From: Simon Davis
Sent: 25 August 2021 12:26
To: 'Susan Leeson' [REDACTED]
Subject: RE: Brookview Nursery WA/58/21/PL

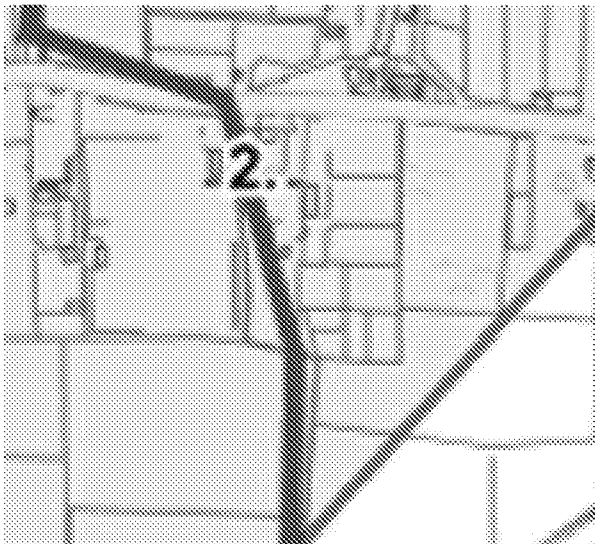
The WNP also has a new biodiversity corridor policy. One of these is Wandleys Copse and the WNP suggests that it goes through your site (see green line below). It probably actually goes down the western side and then along the southern end following the line of the ditches before heading south again but the WNP shows it going through the site and so without clarification, I have to deal with it as shown. If you want to query this, I suggest you speak with the Parish.

Anyway, I note that you are proposing to remove trees along the western and southern boundaries and so I think you would be in conflict with policy VE10 which states:

This conflict is likely going to make this very difficult to get through the DC Committee. You may be able to resolve this by layout changes/biodiversity net gain proposals.
